ADDENDUM NO. 3:

Date: February 10, 2026
 Project: Verbena HS Gym
 DCM# 2025629
 WSM# 25-032

Owner: Chilton County Board of Education
 Architect: Ward Scott Morris Architecture, Inc.

5 ENLARGED CONCESSIONS
1/4" = 1'-0"

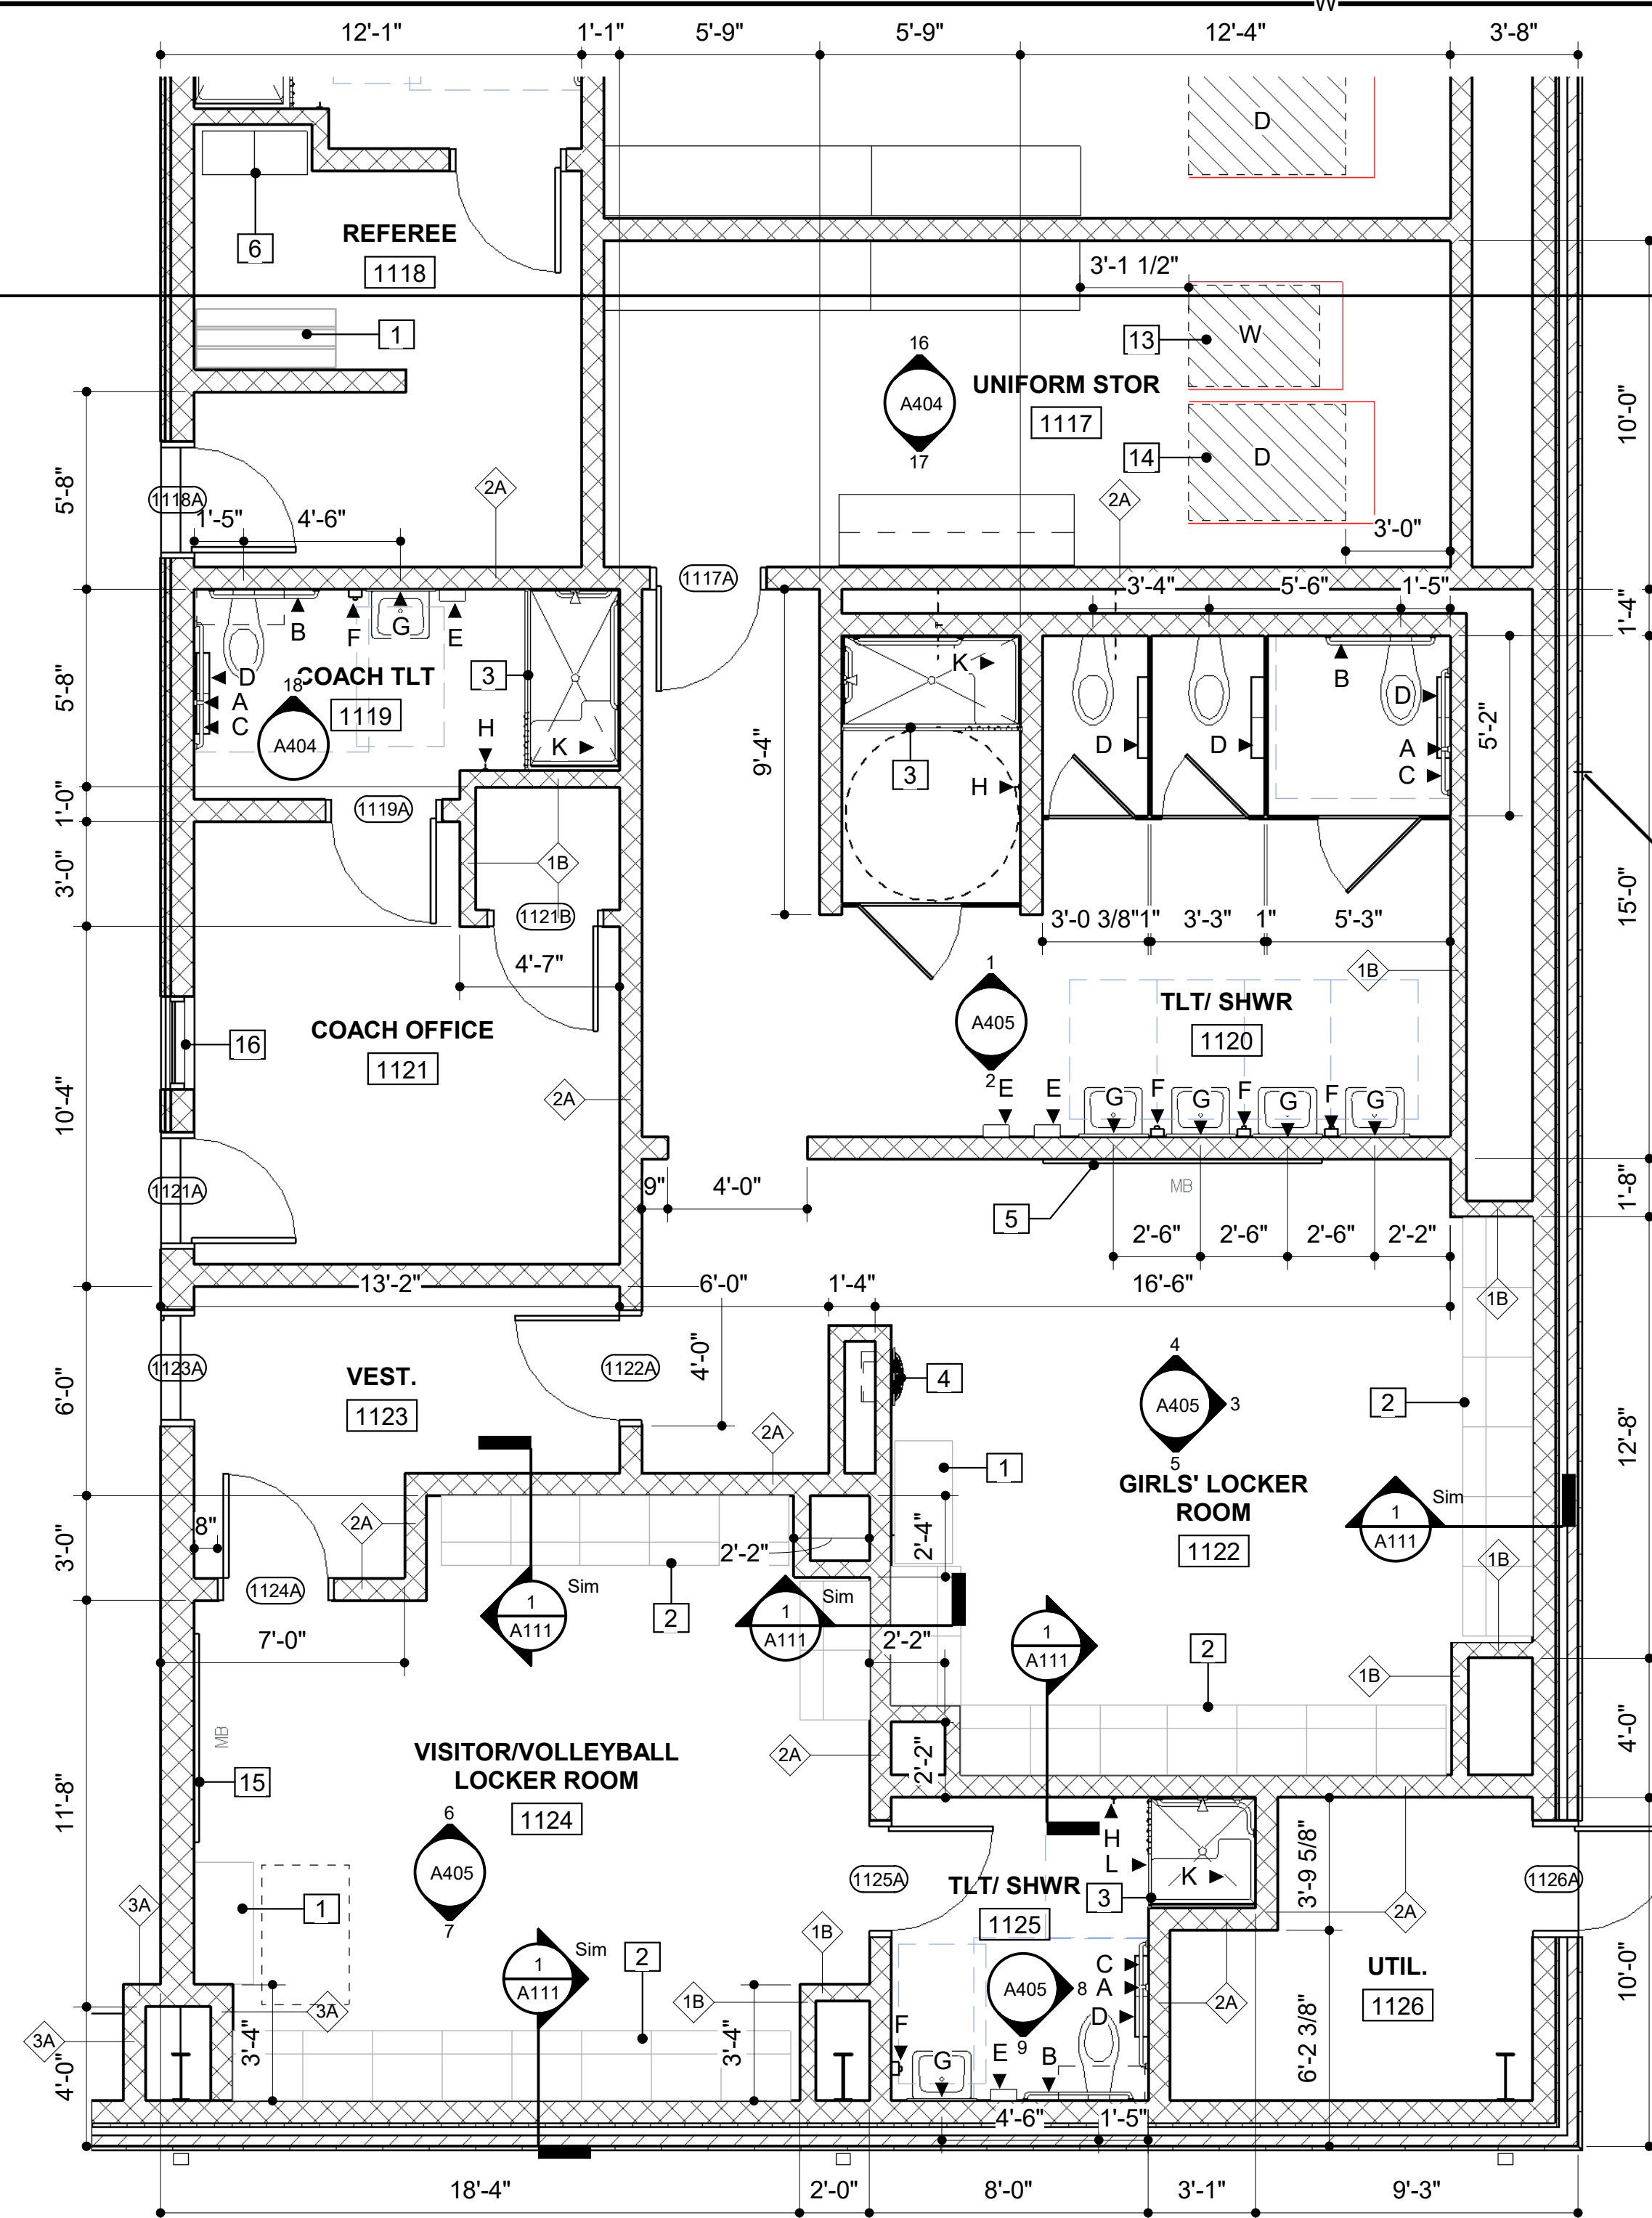
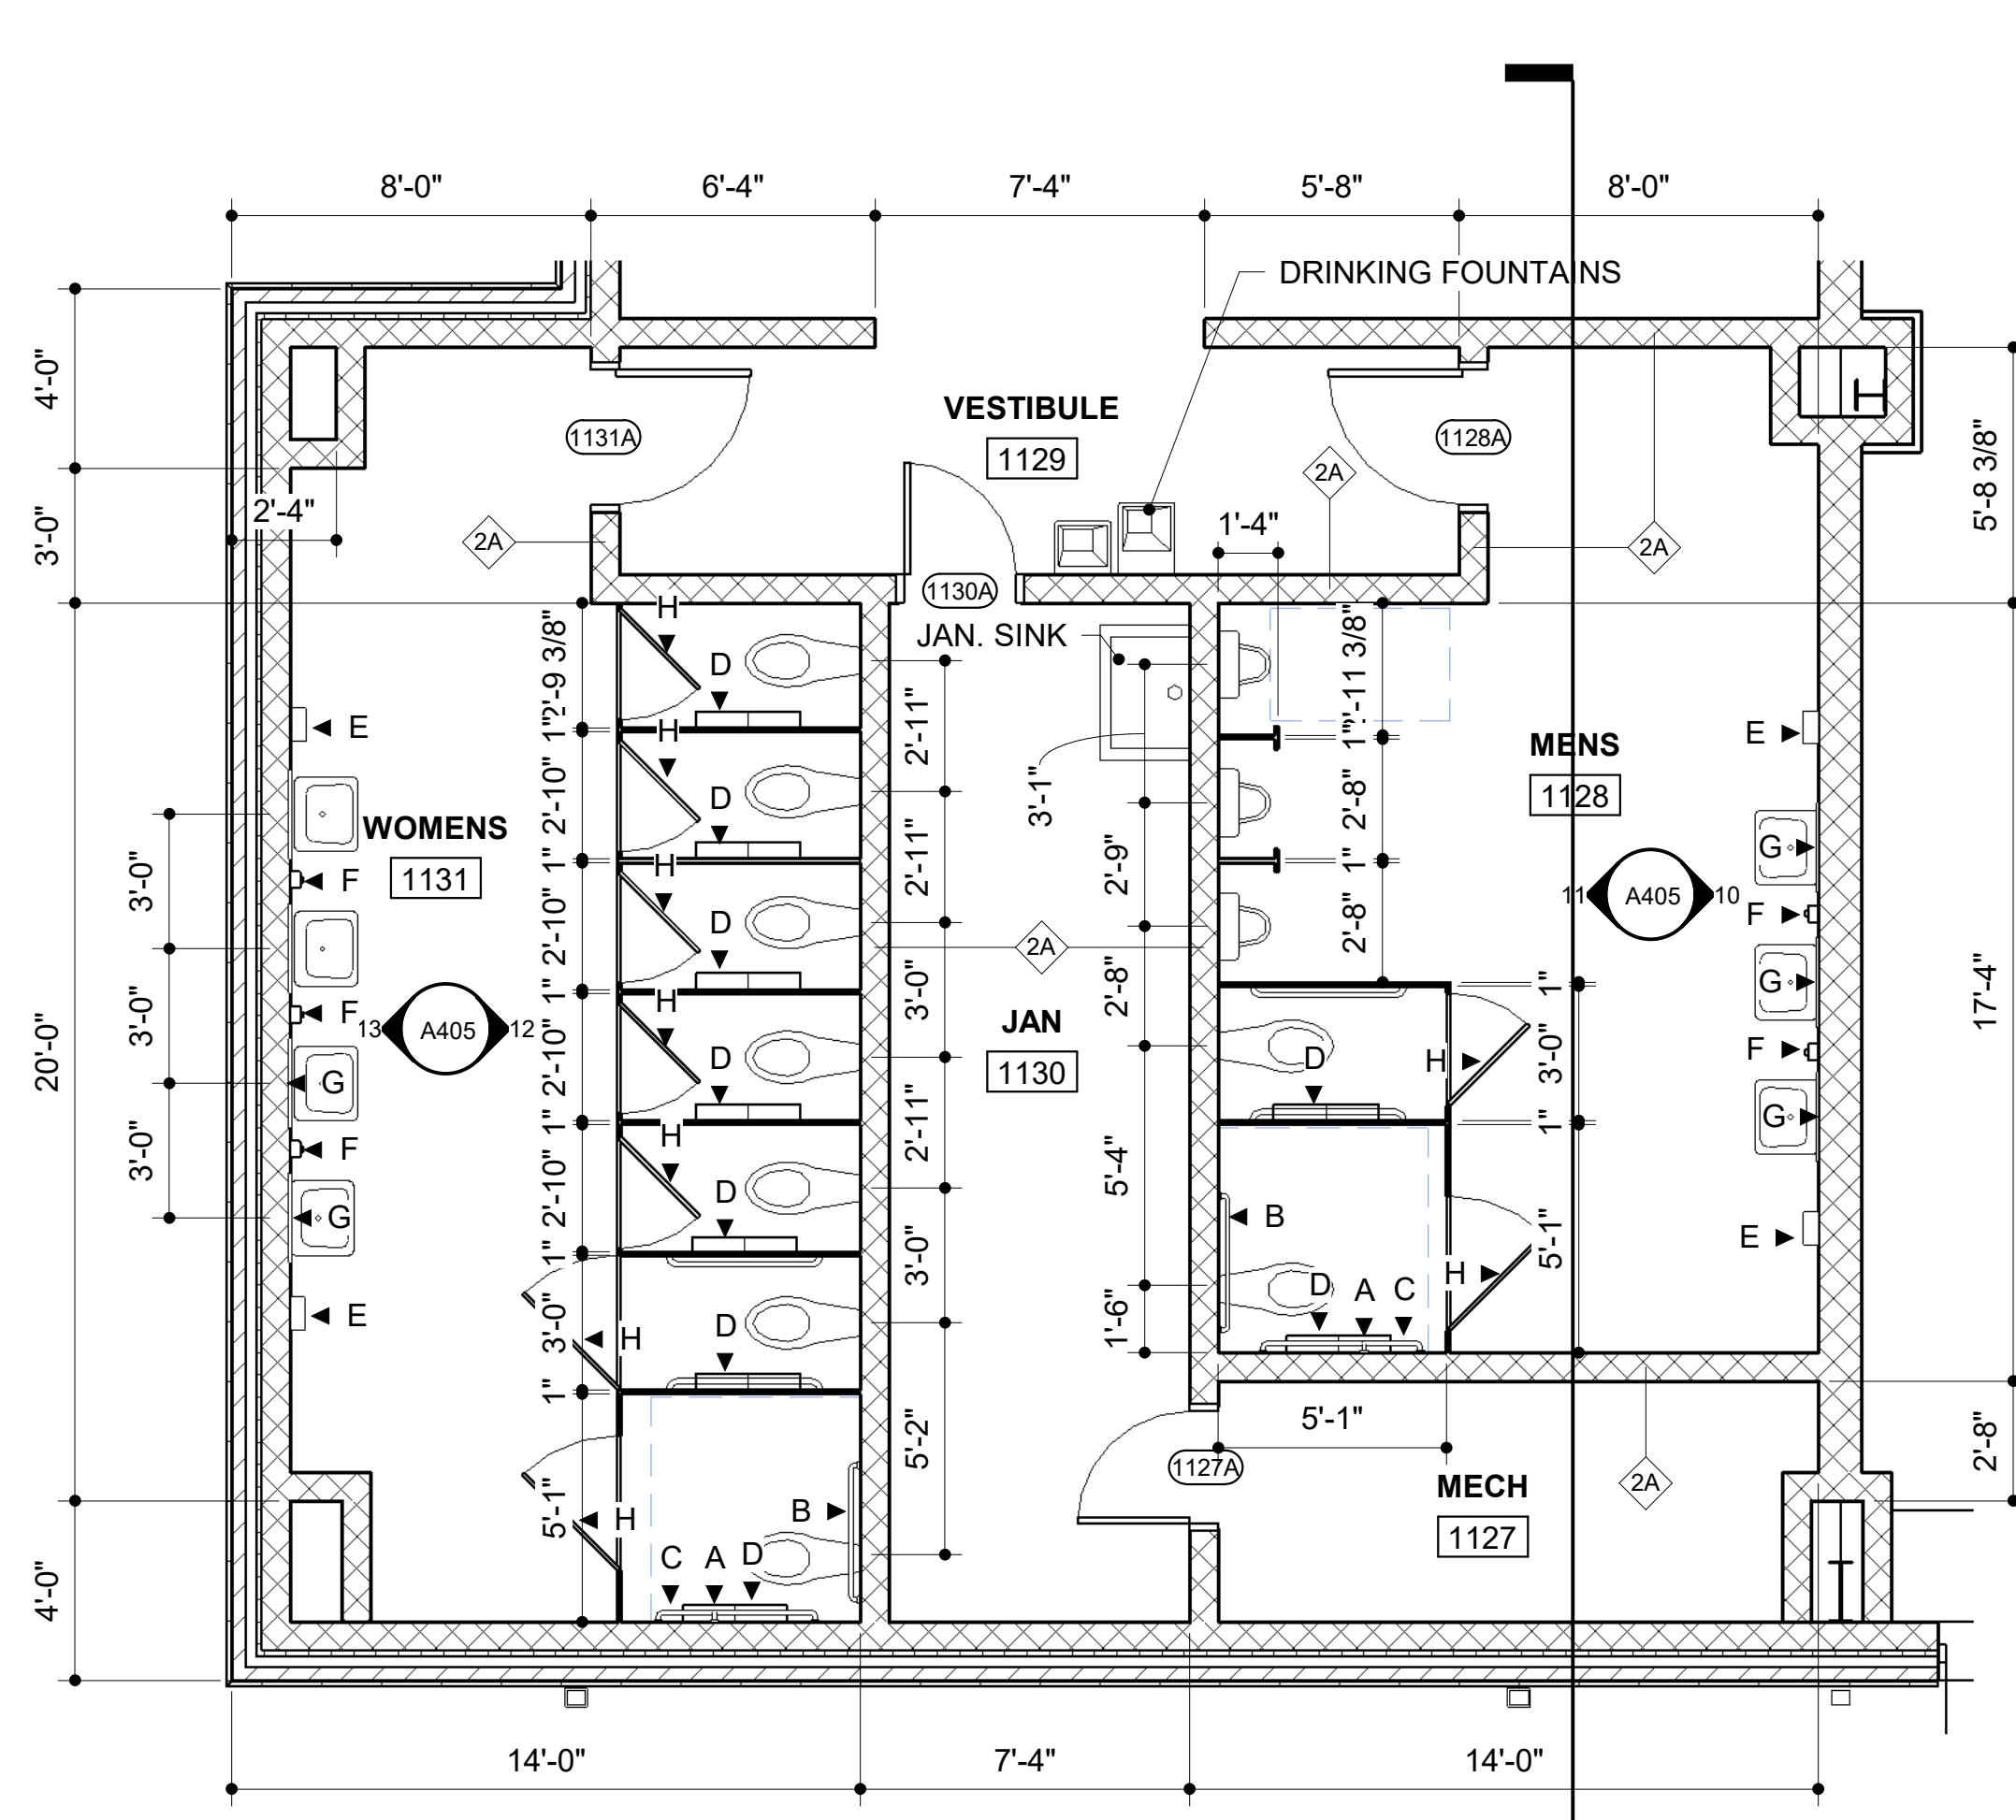
- A. Structural Sheets S000, S100, S500; Refer to attached revised drawings for wall relocation between Rooms #1104 and #1105.
- B. Sheets A002; Refer to attached revised drawing for door and glazing changes.
- C. Sheets A101, A111 and A301; Refer to attached revised drawings for wall relocation and door added between Rooms #1104 and #1105.
- D. Sheet A103; Kitchen Equipment Schedule; change R/F model numbers to TS-24F-FLX-HC, TS-23F-FLX-HC, all stainless-steel exterior.
- E. Sheet A103 and A111; Addendum No. 1 item 1.3.H; R/F-2; change this model number to TS-49FG-FLX-HC-FGD01, all stainless-steel exterior.
